# Product Change Notice (PCN)

PCN Number: **PCN-0451210R-01**

Product(s) Affected: **PJ-059A**

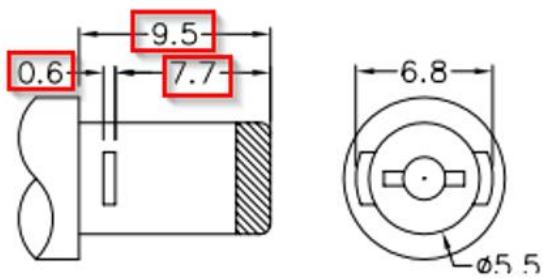
Description of Change: **Minor Housing and footprint differences. Material Change on the housing and terminals. See image Below**

PREVIOUS CUI DEVICES DETAIL / IMAGE			NEW CUI DEVICES DETAIL / IMAGE		
	MATERIAL	PLATING	DESCRIPTION	MATERIAL	PLATING/COLOR
center pin	copper	nickel	center pin	brass	nickel
terminal 1	brass	tin	terminal 1	brass t=0.30	tin
terminal 2	copper alloy	tin	terminal 2	bronze t=0.25	tin
terminal 3	brass	tin	terminal 3	brass t=0.30	tin
plastic	PBT		cover	PBT (UL94V-0)	black
			housing	PBT (UL94V-0)	black

MATING PLUG  
Jack Insertion Depth: 9.8 mm

MATING PLUG  
Jack Insertion Depth: 9.5 mm
